Access Compliance Report Public Rights-of-Way (Curb Ramps)

Main Street: ARROYO_AVE		Cross Street: GLENAIRE_DR		Location:	W
ADA ID: RPRK211013115722	Ramp Type: Type 4 - Parallel	Initial Pass/Fail: Fail	Overall Compliance: No	Severity Score:	45
Codes/Mitigation Info/Possible Solution			Field Measurements/Component Compliance

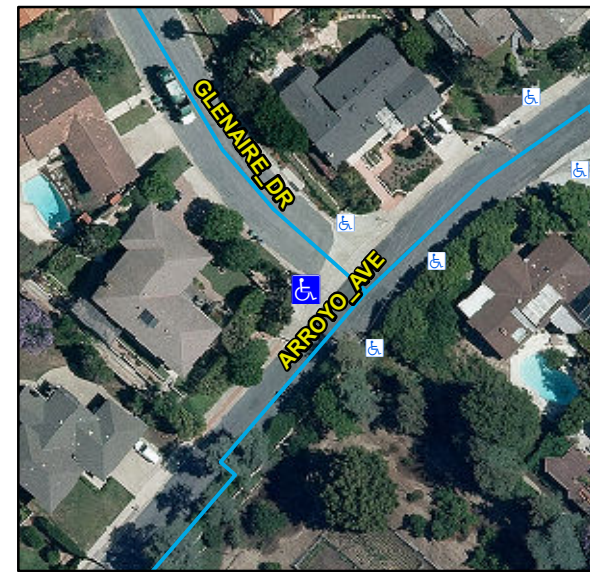
R204.3, R304.3.2, R304.5.3, STD 1115

Compliance	Description	Data	Compliance	Description	Data
N/A	Ramp Length LT (in)	133	N/A	Ramp Length RT (in)	124
Yes	Ramp Width LT (in)	80	Yes	Ramp Width RT (in)	80
No	Ramp Run Slope LT (%)	9.3	No	Ramp Run Slope RT (%)	19.5
No	Ramp Cross Slope LT (%)	6.8	No	Ramp Cross Slope RT (%)	4.5
N/A	Landing Present	N/A	N/A	DWS Provided	N/A
N/A	Landing Length (in)	N/A	N/A	DWS Contrast	N/A
N/A	Landing Width (in)	N/A	N/A	DWS Length (in)	N/A
N/A	Landing Run Slope (%)	N/A	N/A	DWS Full Width	N/A
N/A	Landing Cross Slope (%)	N/A		DWS Offset Type	N/A
N/A	Landing Movement Obstructed?	N/A	N/A	DWS Offset Left (in)	N/A
	Landing Movement Type	N/A	N/A	DWS Offset Right (in)	N/A
N/A	Landing Shared	N/A			
N/A	Clear Space	Yes			
N/A	Clear Space To Crosswalk (in)	N/A			
N/A	Marked Crosswalk 1	No	N/A	Marked Crosswalk 2	No
	Crossing 1 Direction	SE		Crossing 2 Direction	NE
	Marked Crosswalk 1 Width (in)	N/A		Marked Crosswalk 2 Width (in)	N/A

N/A	Ramp Inside Crosswalk 1	N/A	N/A	Ramp Inside Crosswalk 2	N/A
	Crossing 1 Slope (%)	10.8		Crossing 2 Slope (%)	8.9
	Crossing 1 Cross Slope (%)	6		Crossing 2 Cross Slope (%)	9
N/A	Gutter Ponding	N/A	N/A	Curb Slope	2.2
Yes	Gutter Lip Height (in)	0		Road Run Slope (%)	12.8
N/A	Gutter Run Slope (%)	N/A		Road Cross Slope (%)	4.8
N/A	Gutter Cross Slope (%)	N/A	No	Perpendicular Joint Present	No
Yes	Overall Surface Condition	Acceptable			
	Cross Gutter Present?	Yes		Spandrel Present?	Yes
	Replace Cross Gutter?	No		Replace Spandrel?	No

Remove & Replace Curb Ramp With Two New Directional Ramps or Equivalent.
